ADDENDUM NO. 4

March 11, 2016

**Re: Sanford High School and Technical Center
12-067-00**

E0.06

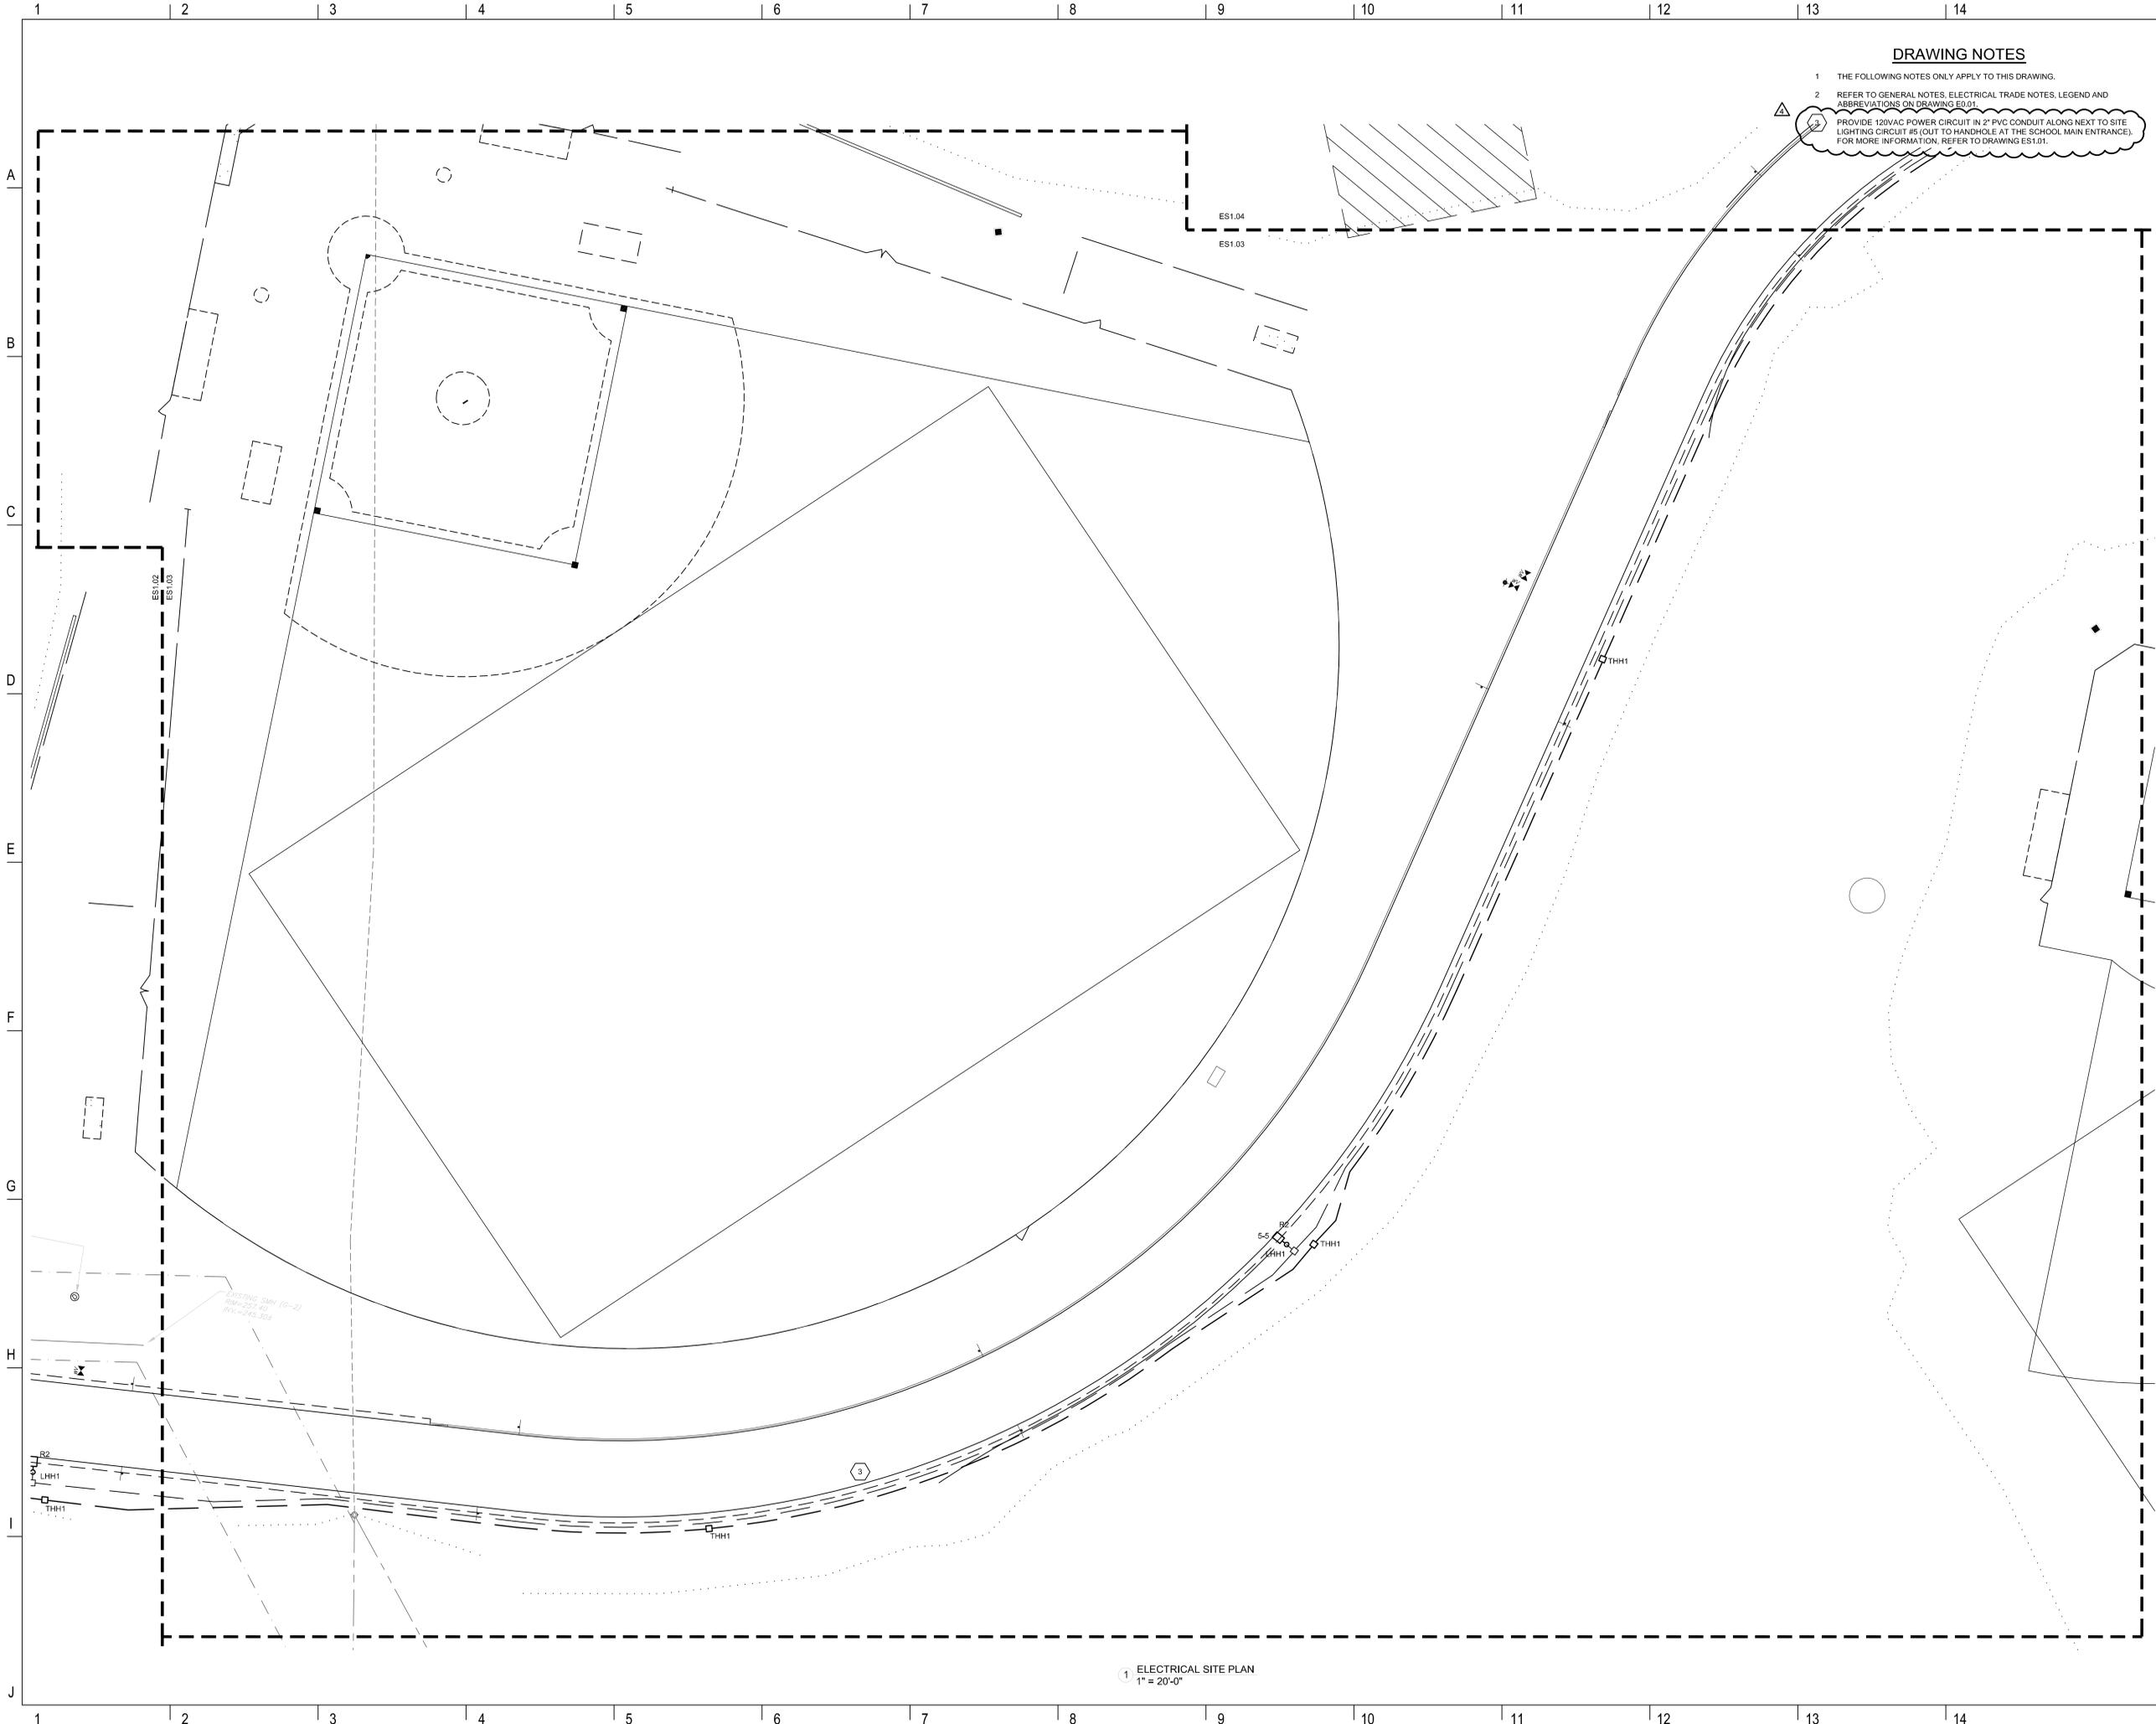
Item No. 4.8 Reference Drawing E0.06 : Question: Special Receptacle Schedule on E0.06: The USB is indicated with an "L" (twistlock) in NEMA?

Answer: "L" removed in Special Receptacle Schedule on USB device.

T1.18

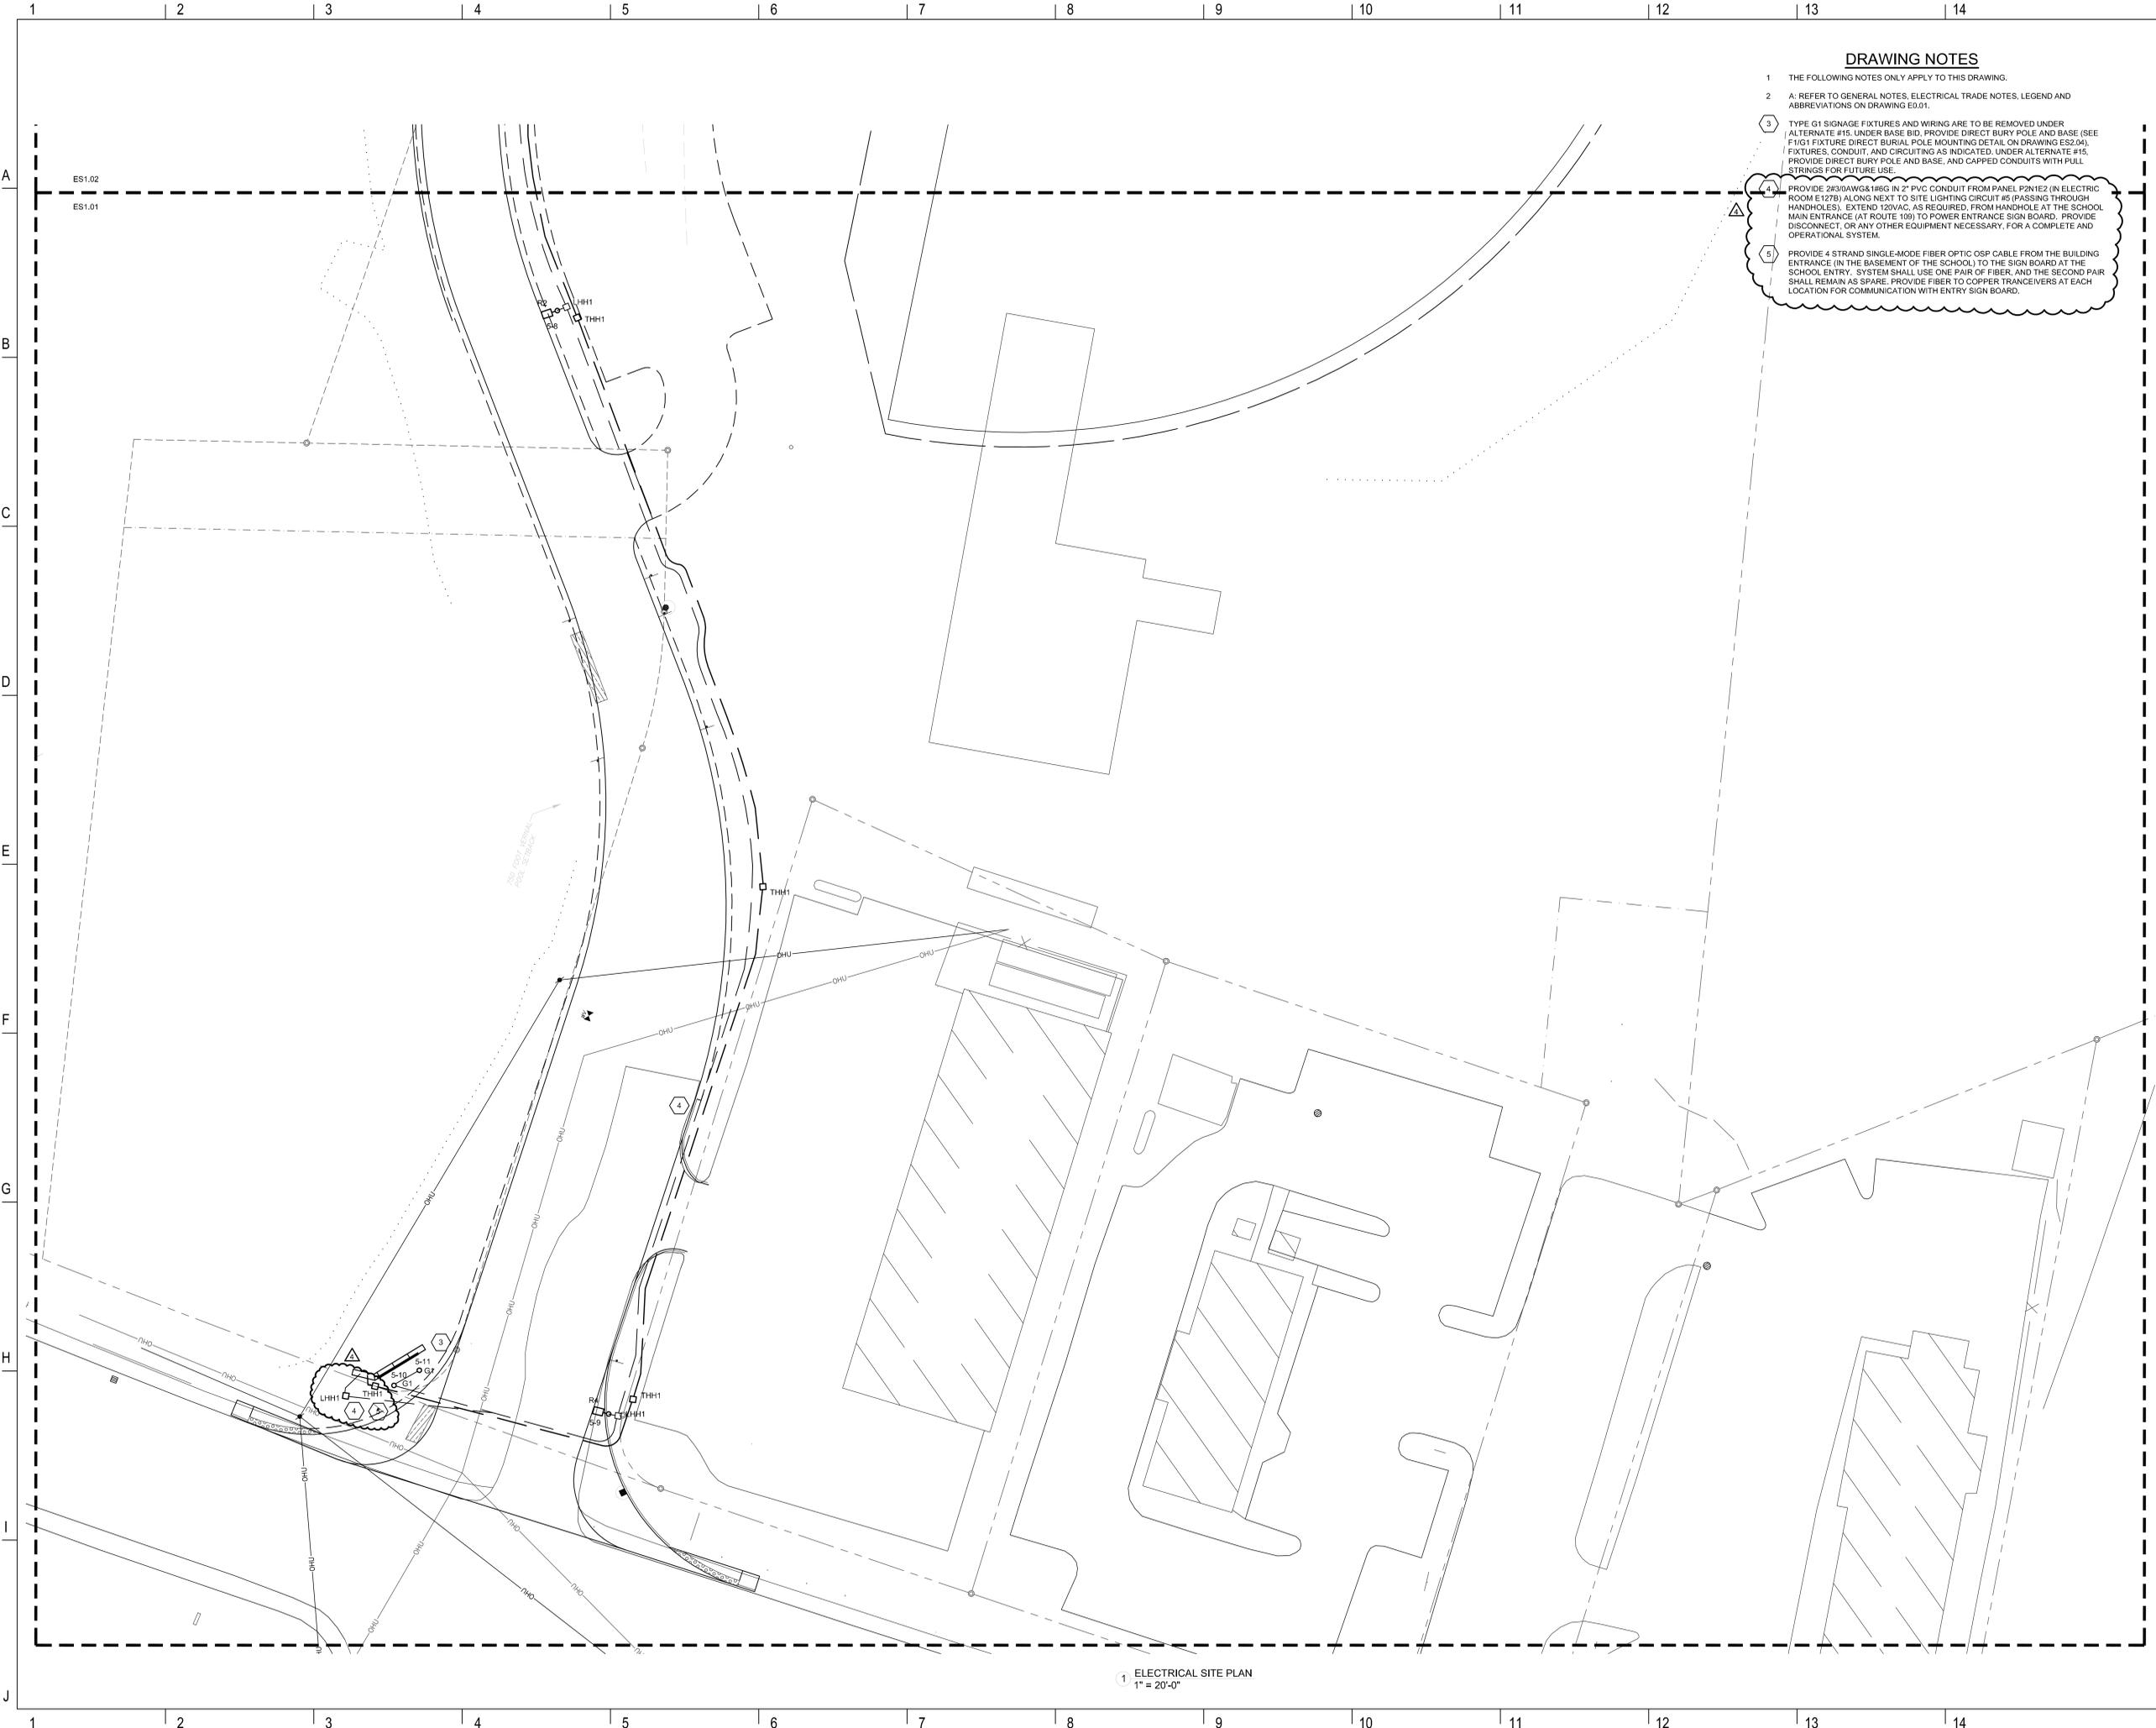
Item No. 4.4 Reference Drawing E2.18. : Question: There are 2 type A4 floorboxes on the E2.18 but only 1 on T1.18. Should we provide voice/data/TV to both locations?

Answer: Yes
